# Rezoning Petition 2024-008 Post Hearing Staff Analysis September 4, 2024

Current Zoning: TOD-TR (transit-oriented development – transition) Proposed Zoning: CG(CD) (general commercial, conditional)

Approximately 0.776 acres located at the northeast intersection of South Boulevard and Starmount Cove Lane, east of England Street.

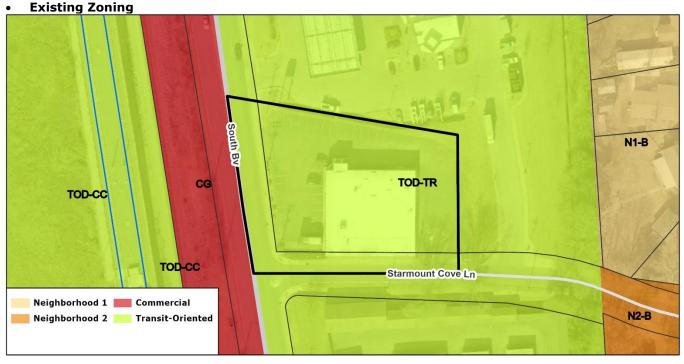
- The petitioner has revised the plans to move the building closer to the South Blvd Frontage, improving the plan, as follows:
    - Created one-way circulation around the building, decreasing the distance from South Blvd to the building entrance.

- Placed a speed hump at the entrance to the parking area to slow traffic where vehicles and pedestrian mix.
    - Providing a raised crosswalk across the drive aisle increasing pedestrian visibility and decreasing vehicle speeds improving access from the Starmount Cove Lane frontage.
